Subject: 46-52 Nicholson Street and 57-67 Christie Street, St Leonards - Planning Proposal

Record No: SU8044 - 70375/20

Division: Environmental Services Division

Figure 4: Sketch of proposal.

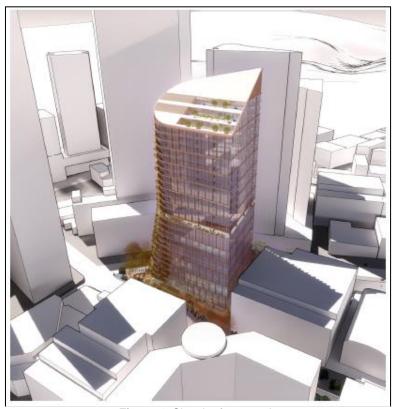
The proposed height of the building is 32 storeys, which is two storeys higher than the 2036 indicative height. Similarly, the proposed FSR is 16.45:1 which is 1.45:1 above the 15:1 of the 2036 Plan.

Additionally, the 3m ground level setback and 4 storey street wall height, which are consistent with the 2036 Plan, create an undesirable built form in terms of bulk and scale.

Notwithstanding the proposal's compliance with the 2036 Plan for setbacks and street wall heights, variations to the indicative FSR and height in storeys is not supportable from an amenity perspective.

Figure 7: Shadow modelling at 10am

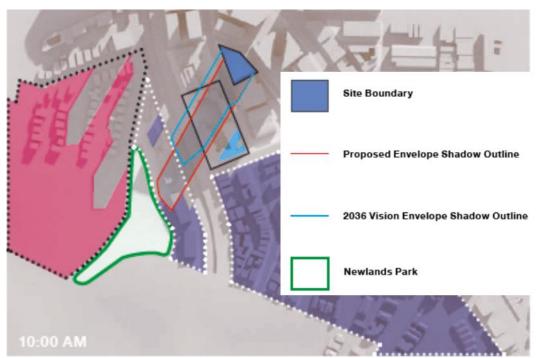
Notwithstanding that, shadow modelling in Figure 7 shows that the proposed building will not overshadow Newlands Park at all after 10am mid-winter. Therefore, the proposed LEP height control in the Planning Proposal is no longer applicable or consistent with the action of the final 2036 Plan.

An RL, as seen in the applicant's proposal (RL 198.6 metres) and/or equivalent height in metres gives assurance of height to adjoining land owners. Based on the above, the definition of height in terms of a solar height plane is uncertain and unnecessary in this Planning Proposal due to a new action in the final 2036 Plan.

Figure 9: Ground Floor Plan of proposal.

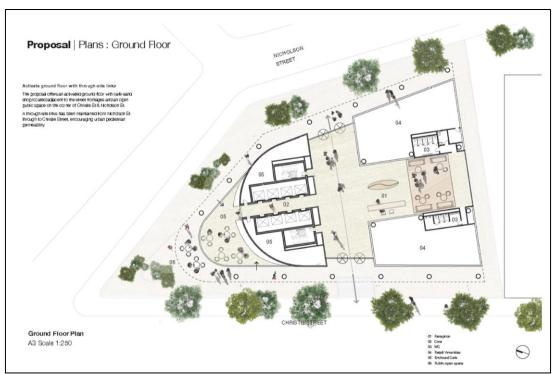
The proposed ground floor plan (Figure 9) shows that there is consistent street tree planting proposed along both street frontages (Nicholson and Christie Streets) but the exact amount of tree canopy cover has not been specified by the proponent.

However, there are no direct actions in the 2036 Plan on tree canopy cover which affect this site. Notwithstanding this, it appears that there is potentially enough space to accommodate increased tree planting if needed, based on the proposed ground floor plan.

Figure 10: Heights and building envelopes with Council's preferred proposal (26 storeys).

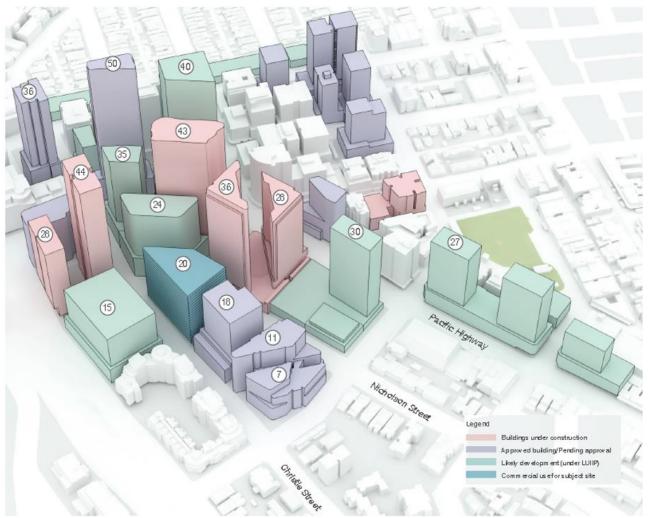
The reduction in height responds to the concerns raised above, by minimising the impacts of over-looking and loss of district views to adjoining/neighbouring residences, as well as transitioning the height and bulk more appropriately to the surrounding context (see figure 10).

It is noted that this revised building envelope is not consistent with Council's current DCP or the 2036 Plan for all setbacks. However, given the amendments to the height of the building, this approach provides a balanced position regarding setbacks between the applicant's proposal, the 2036 plan and the DCP.

- 26 storeys, with 24 office floors plus a plant level plus part rooftop plant;
- 15:1 FSR;
- 8 storey podium (street wall height) with 0m setback along Christie Street;
- 3m setback to Nicholson Street and southern boundary (rear); and
- 3m setback above podium.
